00 91 04 ADDENDUM NUMBER NO. 4

Owner: Laguna Madre Water District
Project: Lift Station Nos. 1 and 37 Rehabilitation
Project No.: LMWD Bid # LS-20-07-01; TWDB Project No. 73730
Addendum No. 4
Addendum Date: September 1, 2020

LAGUNA MADRE WATER DISTRICT
LIFT STATION NOS. 1 AND 37 REHABILITATION
 LIFT STATION NO. 37
MECHANICAL PLAN AND PROFILE
(ALTERNATE NO. 1)

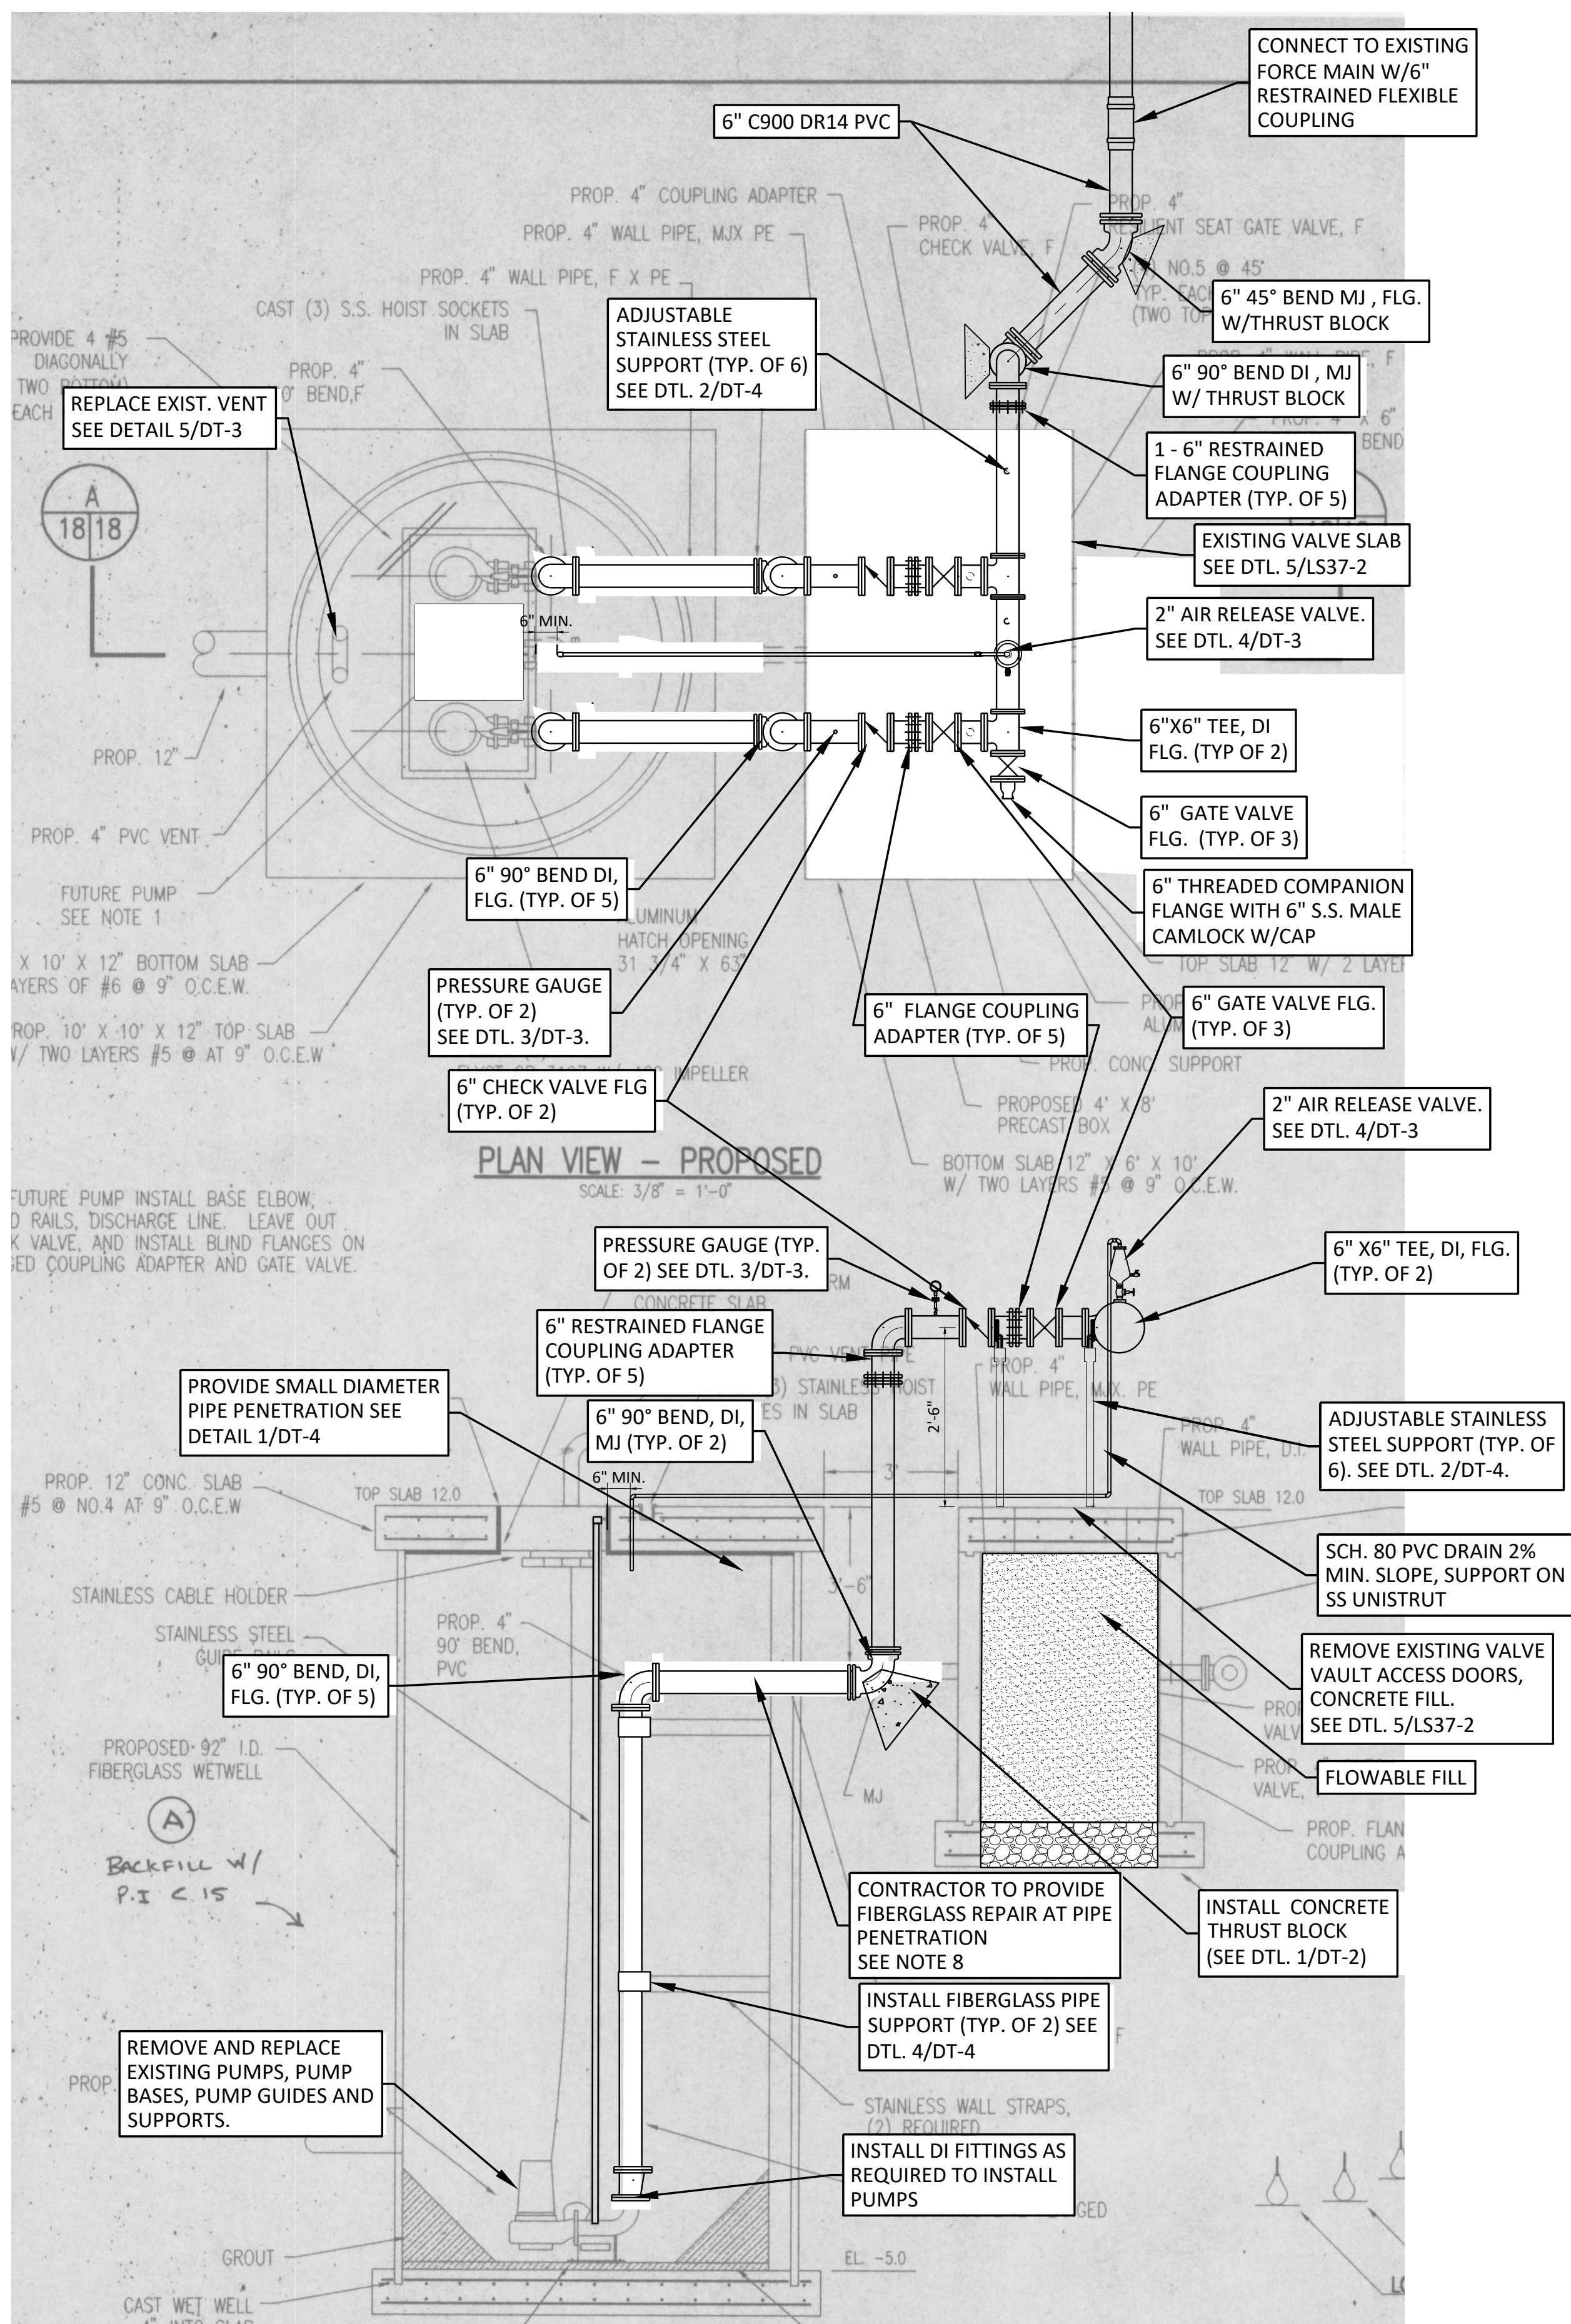
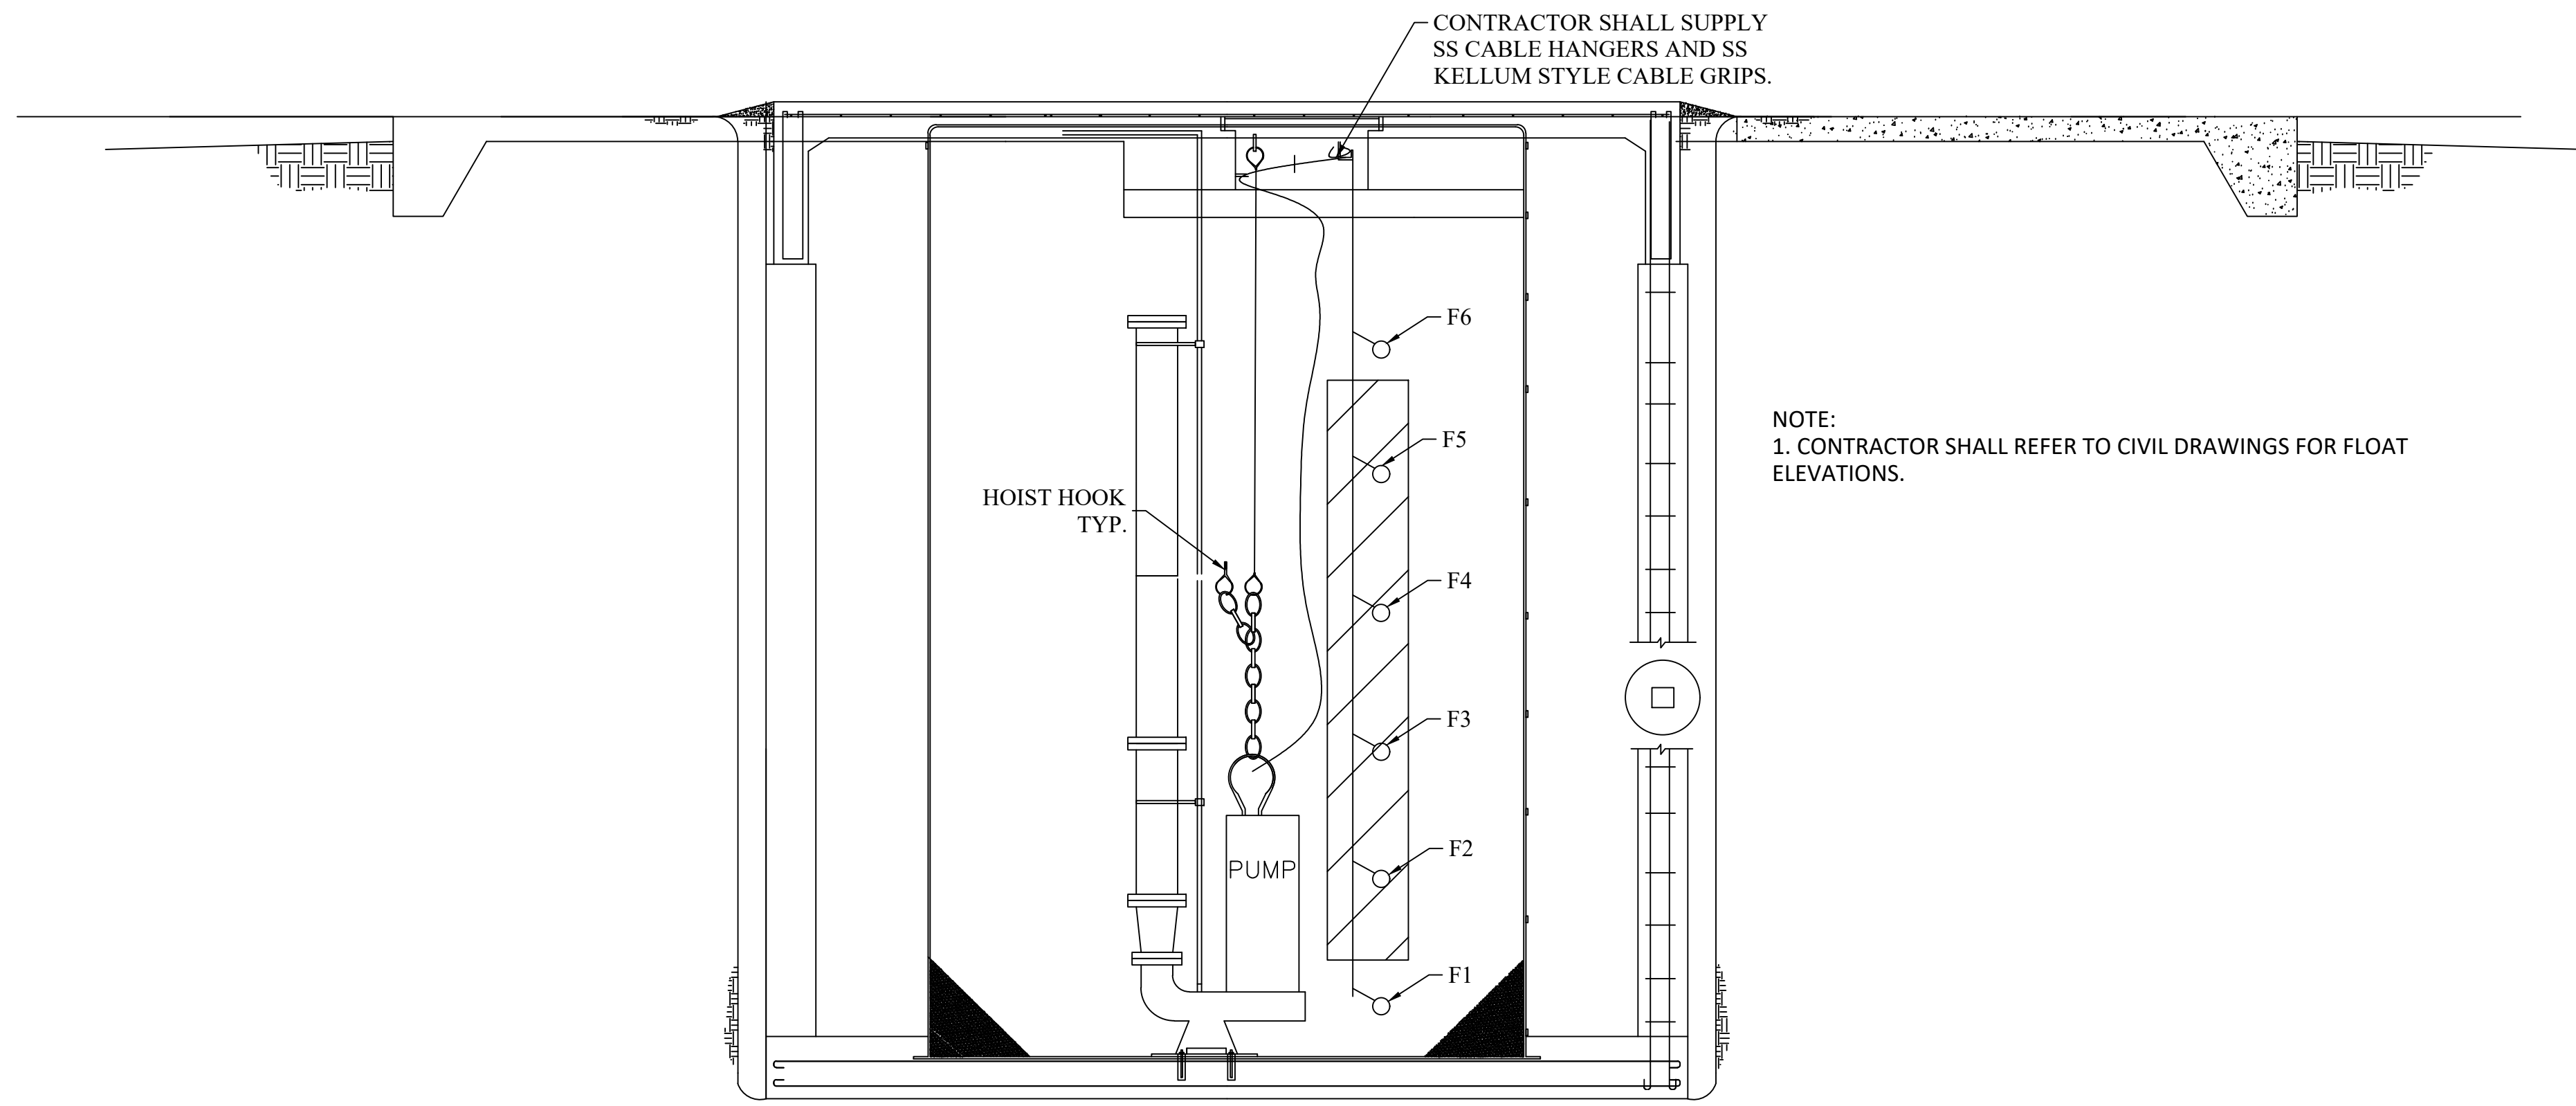
| Drawing No. | Drawing Title |
|-------------|---|
| LS37-A1-2 | Mechanical Plan and Profile (Alternate No. 1) |

LIFT STATION NO. 37
ELECTRICAL WETWELL DETAILS (ALTERNATE #1)

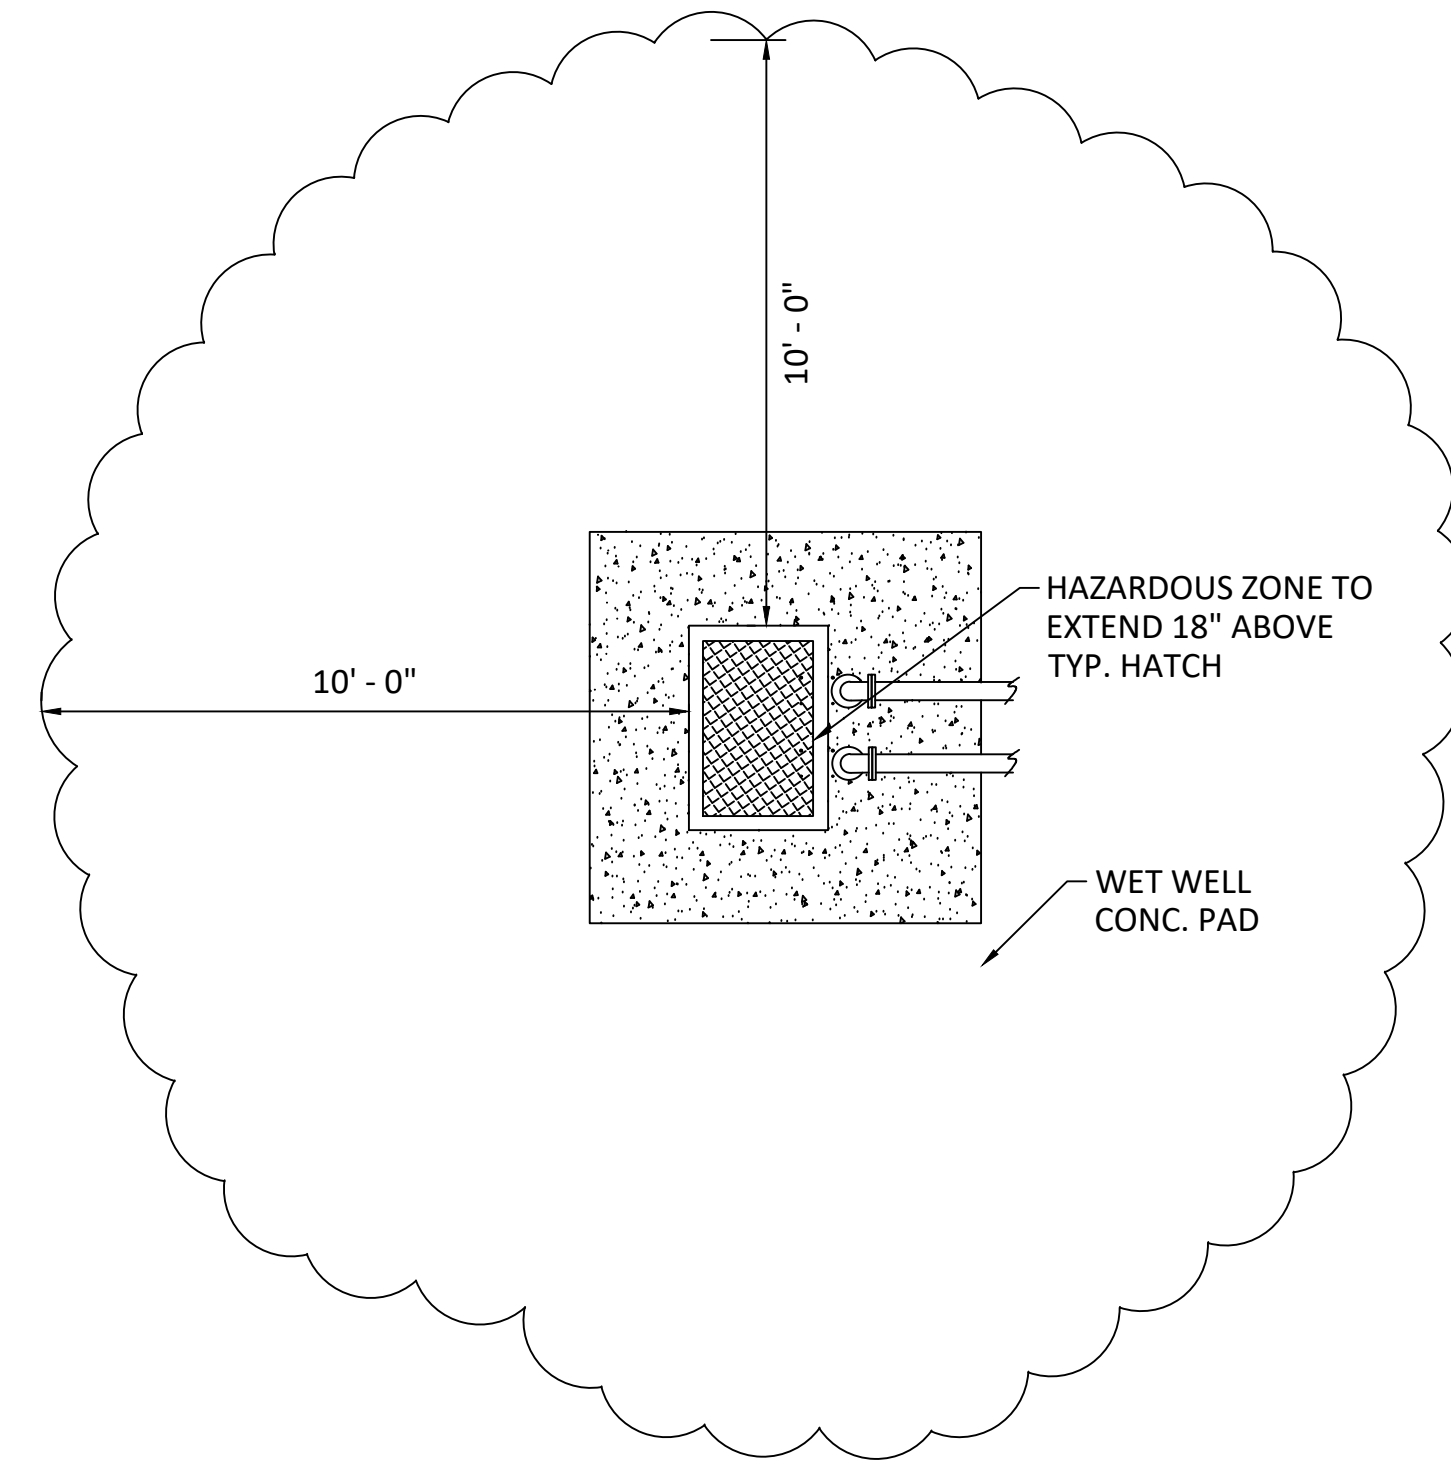
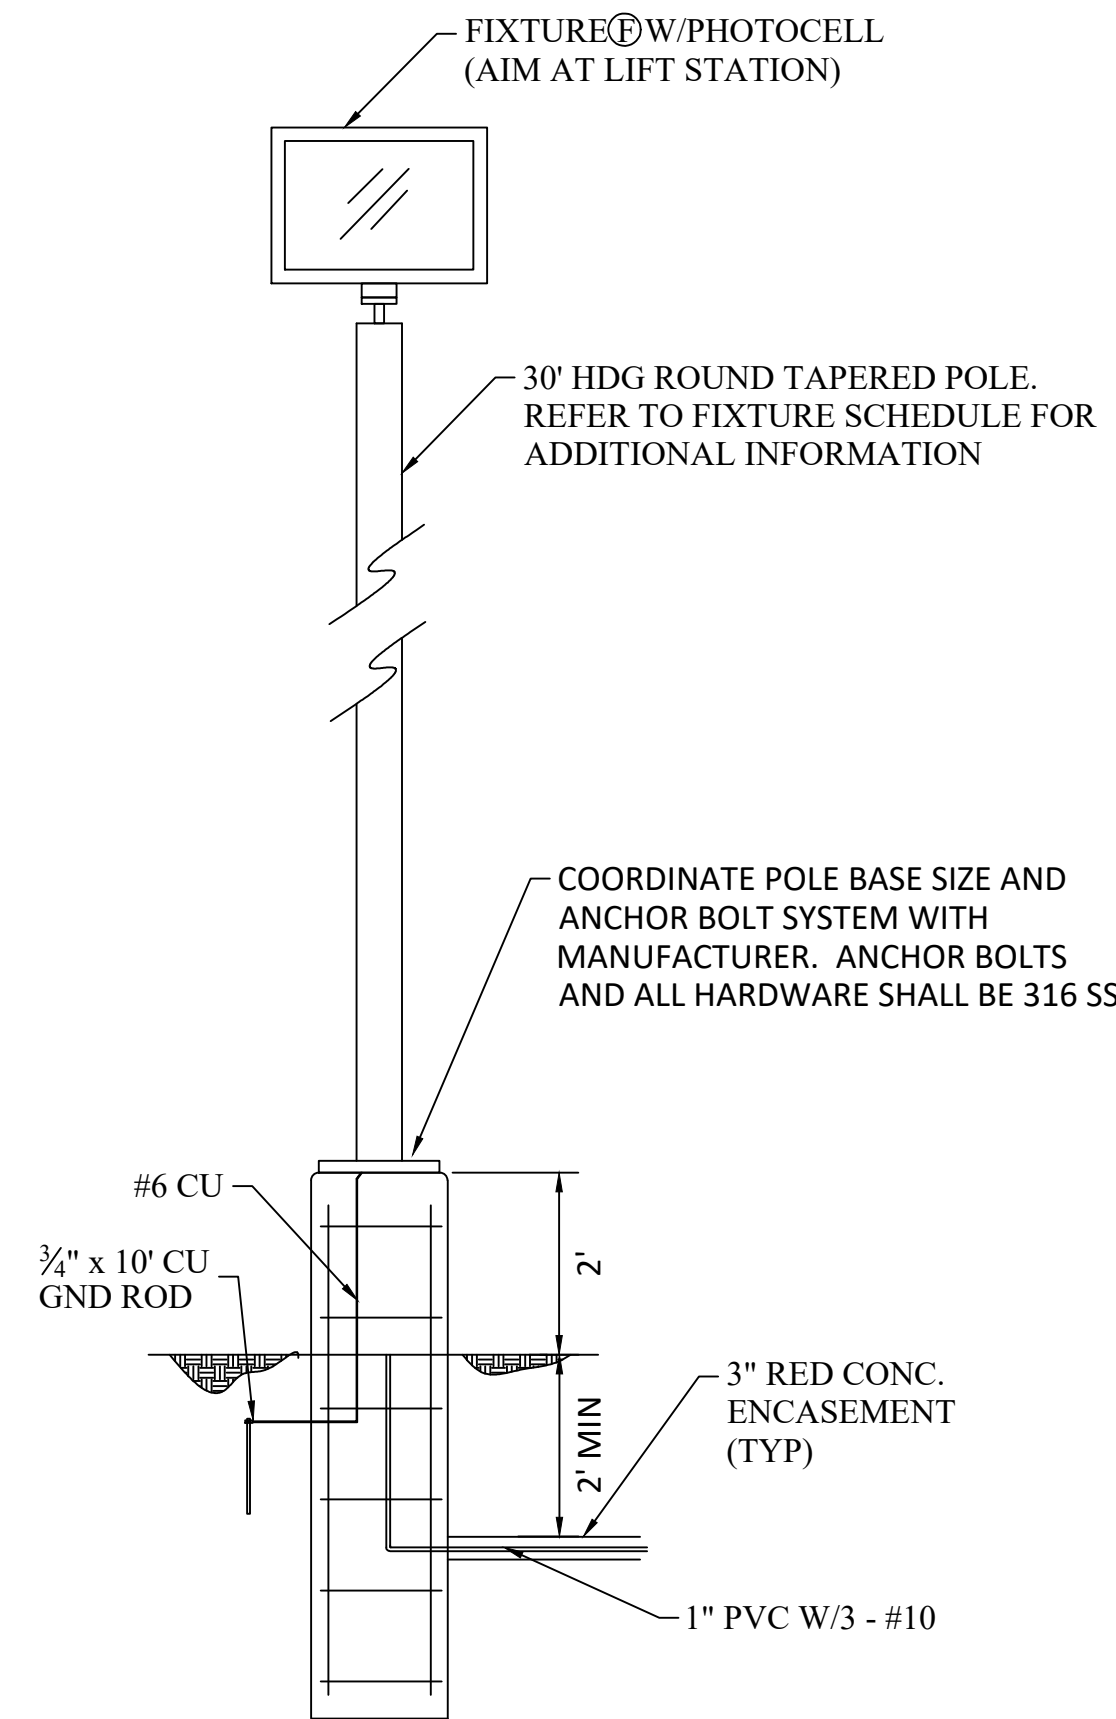
| Drawing No. | Drawing Title |
|-------------|---|
| LS37-A1-3 | Electrical Wet Well Details (Alternate No. 1) |
